Response to Guildford Borough Council's Consultation on its Air Quality Action Plan for Compton Village dated May 2019.

1. This response has been prepared jointly by Compton Parish Council's Traffic Committee and by the owners of the three properties which are within the Air Quality Management Area (AQMA).

Fig 1

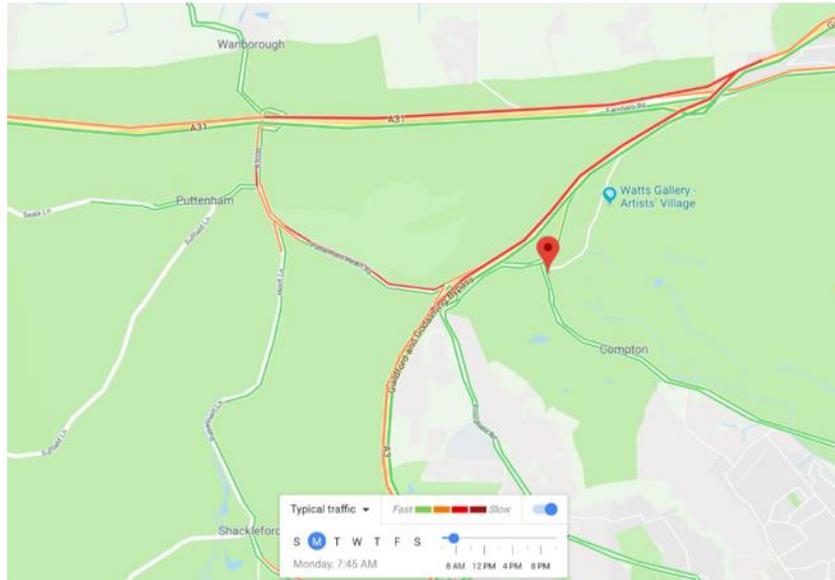
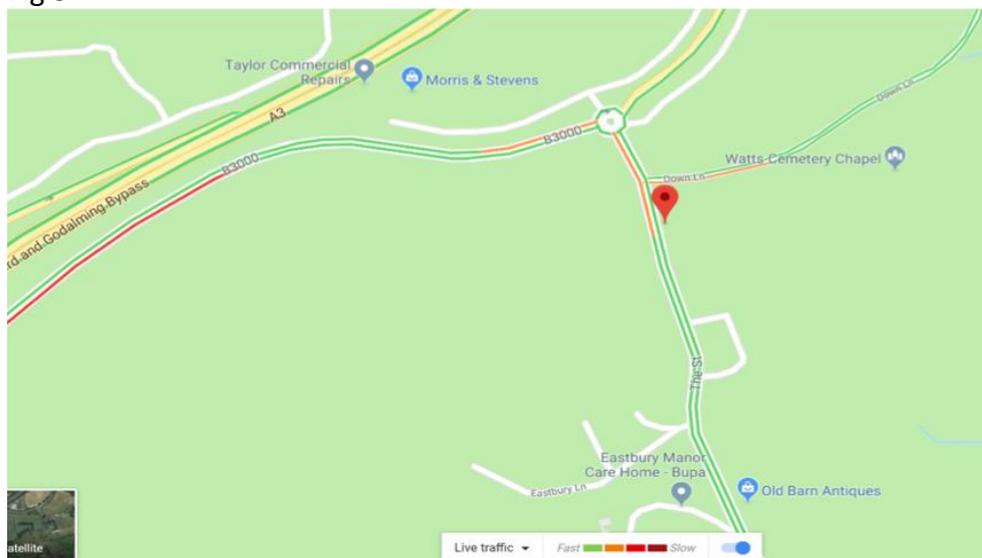
Timed print screens from Google Maps were taken which show that an accident at a peak time at the point on the A31 close to the new proposed access to the Blackwell Farm development, caused complete gridlock in Compton in under 8 minutes. The same level of congestion on this loop is shown as a “typical traffic” scenario (Fig 1) which occurs frequently at peak times. Fig 2 is a close up of Fig 1 to include B roads and Fig 3 is a snapshot at 5pm showing that the build-up of traffic at the roundabout has caused congestion in Compton.

Fig 4

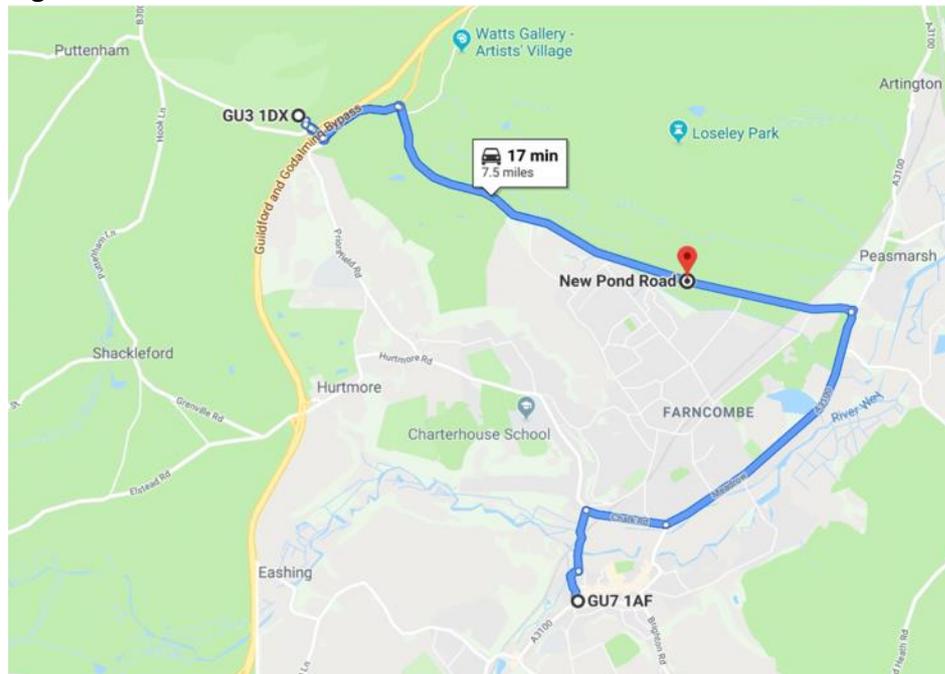
SCC’s responses indicate that they do not support re-routing freight on the basis that the alternative route is longer. However, Google Maps show that the route to the car park on Flambard Way, Godalming via the B3000 is 7.5 miles and takes 17 minutes by car. The route via the A3 and Milford is 5.4 miles and takes 9 minutes. See Fig 4 and Fig 5.
